Land at Bird in Eye Farm
South of Bird in Eye Hill
Uckfield

TRANSPORT ASSESSMENT ADDENDUM

ITR/MT/5330/TAA.4
March 2022

CLIENT	Croudace Homes Ltd.	DATE	02/02/22
PROJECT	Bird in Eye, Uckfield	DESIGN BY	JCB
TITLE	Suggested Line and Level Detailed Design for Proposed Access	DRAWN BY	JCB
		CHECKED BY	MT
		SCALE	1:500 @ A3
DRAWING No.	5220 / 1001	REV No.

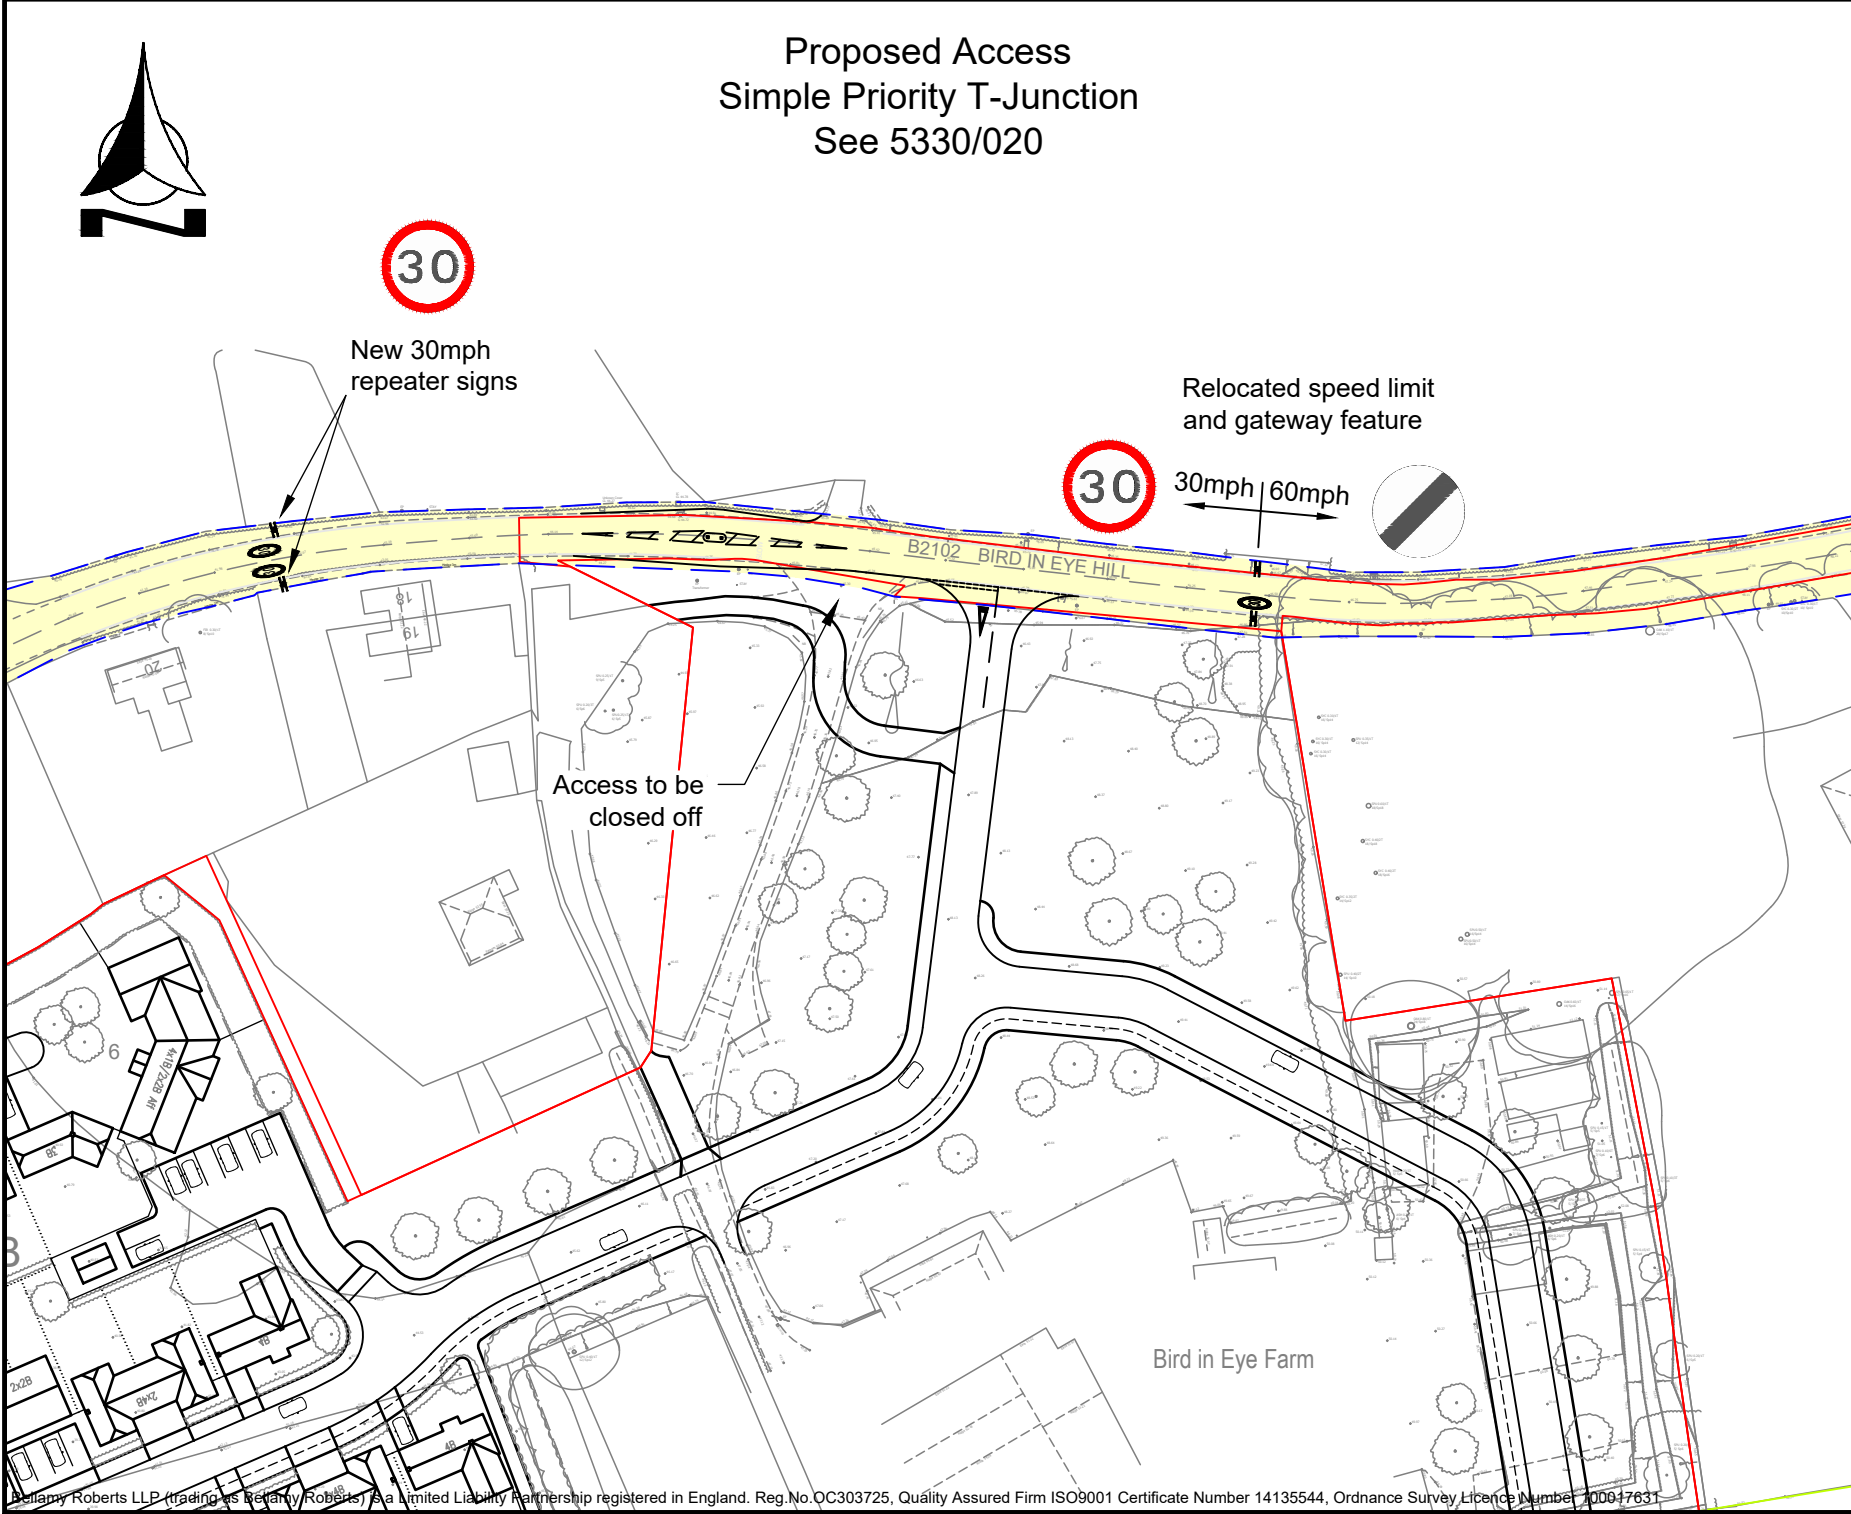
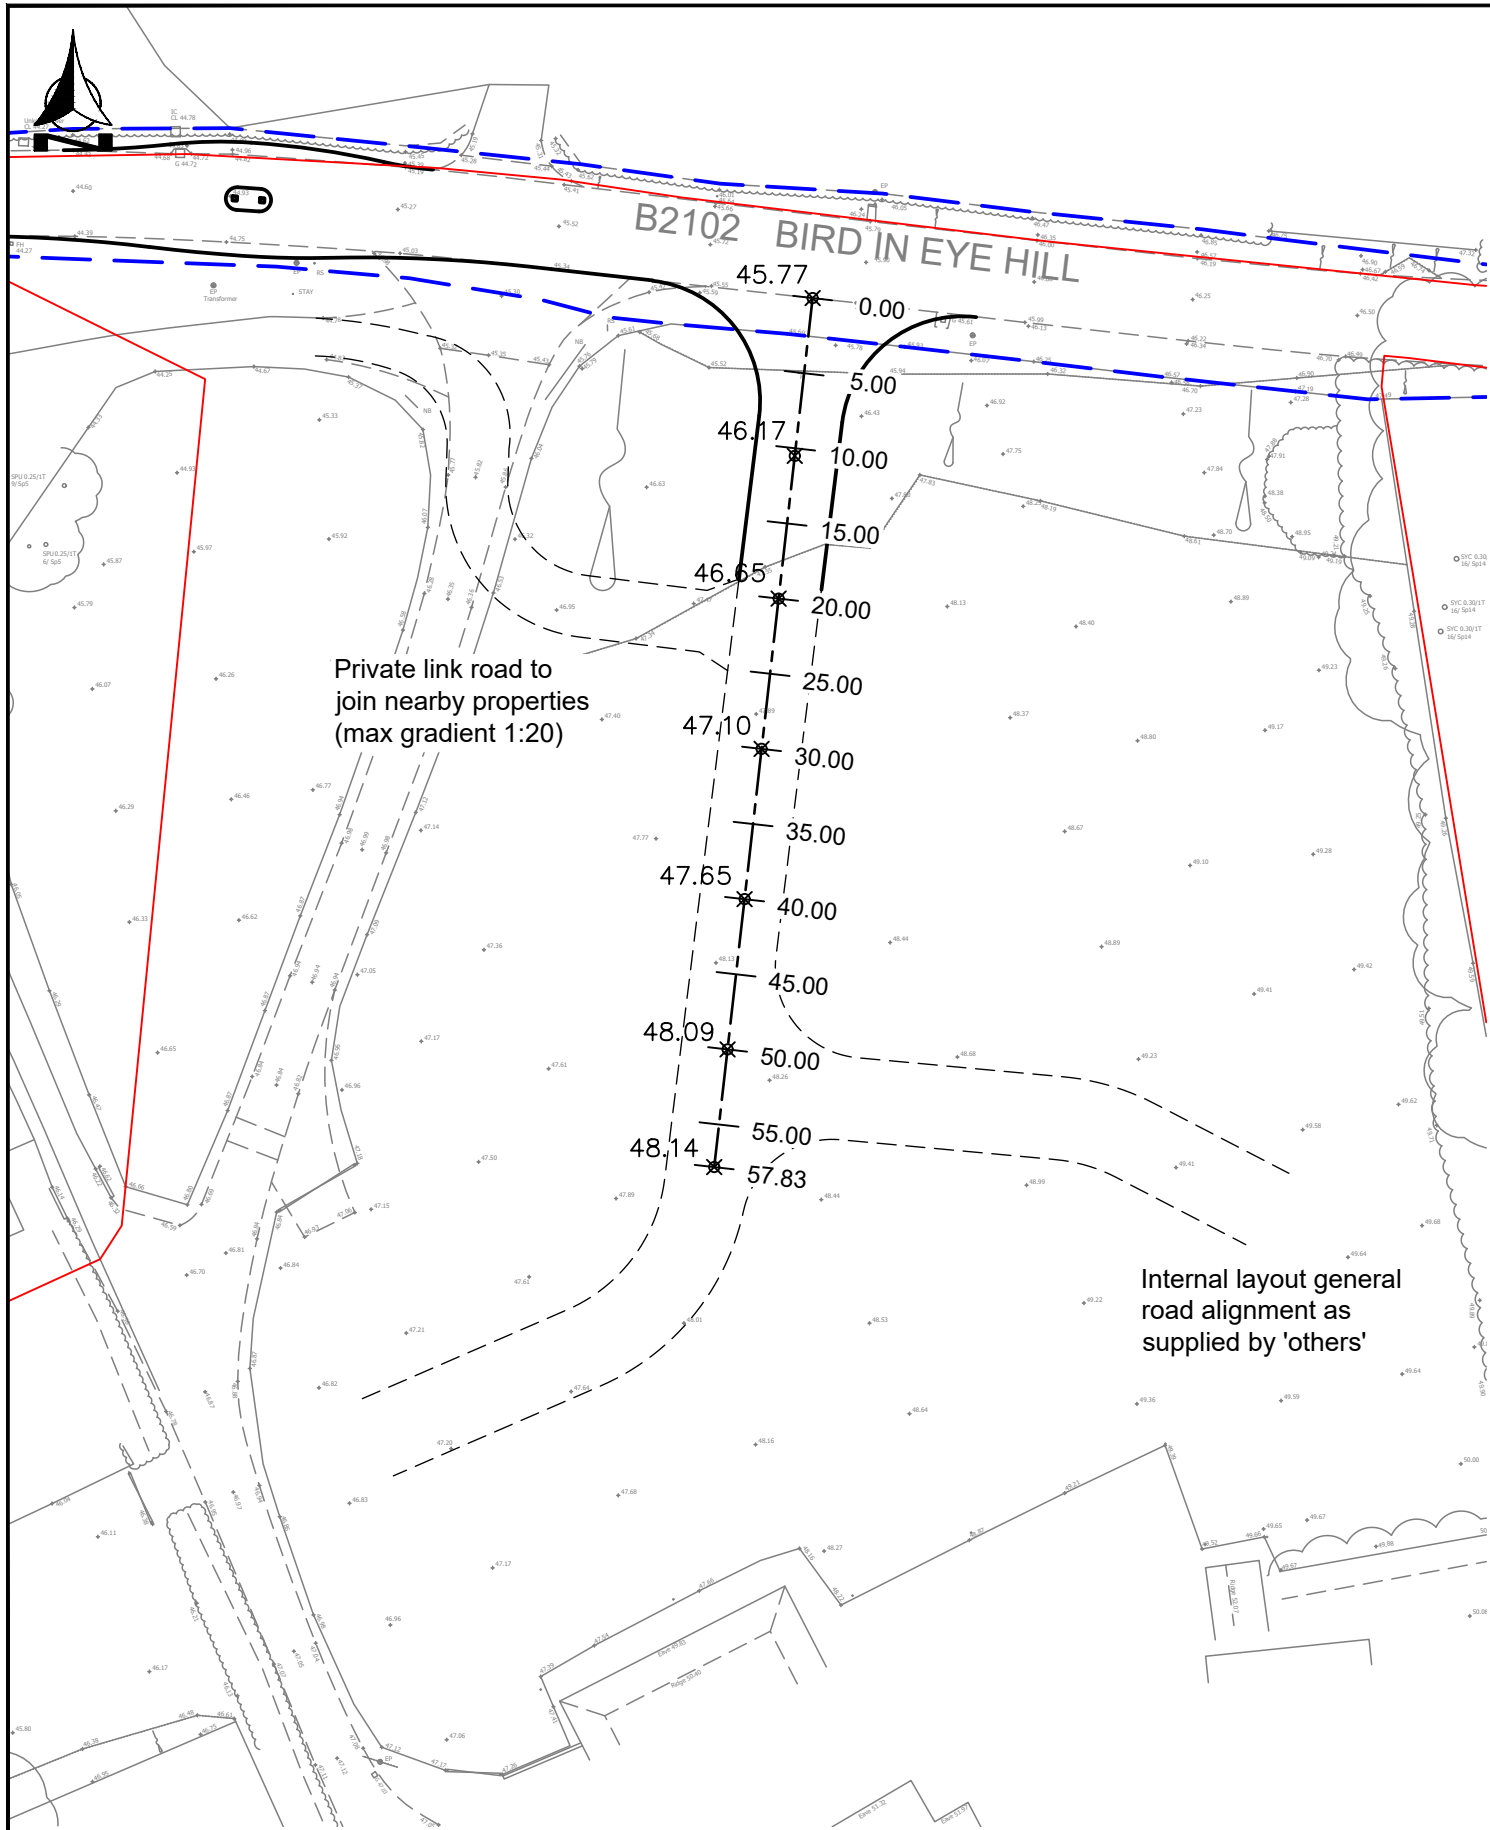
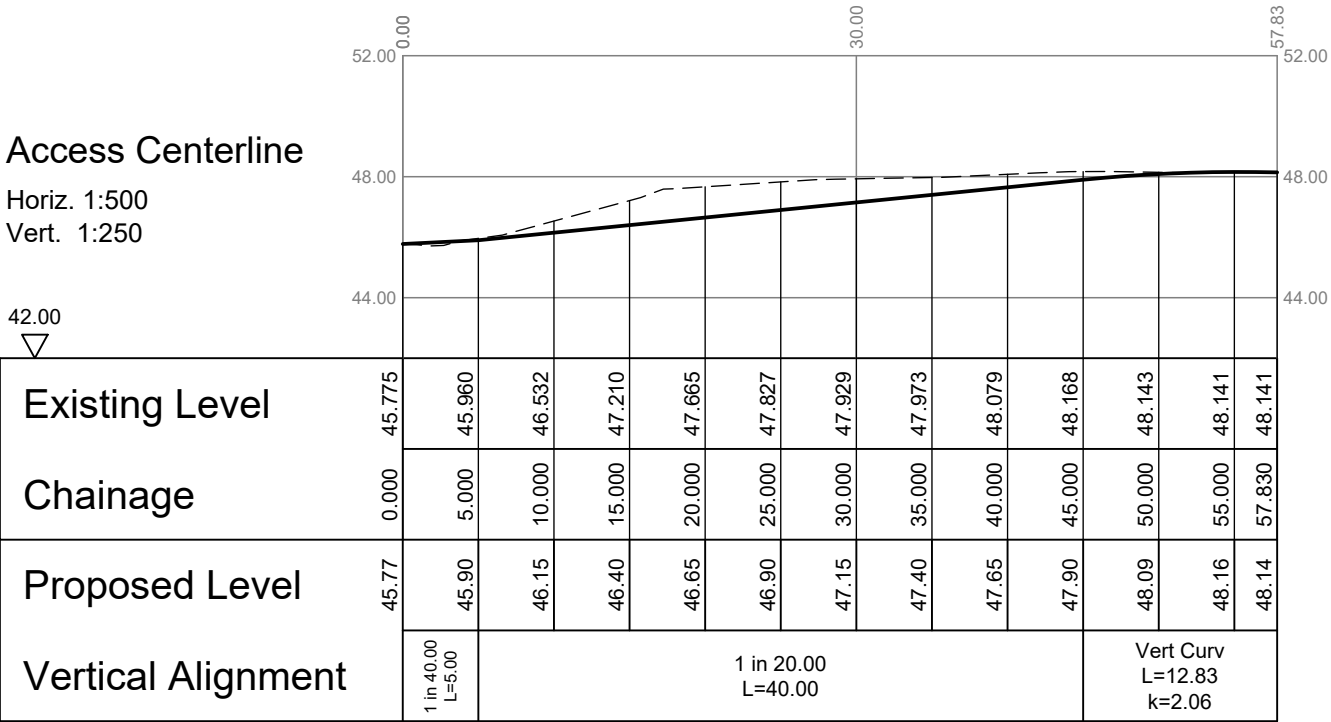
Local Highway Authority Comment: Request for further detail of the site access showing an appropriate gradient of 1 in 20.

Bellamy Roberts Response: A line and level drawing has been prepared (5330/1001), see drawing 5330/1001 at **Appendix 6**.
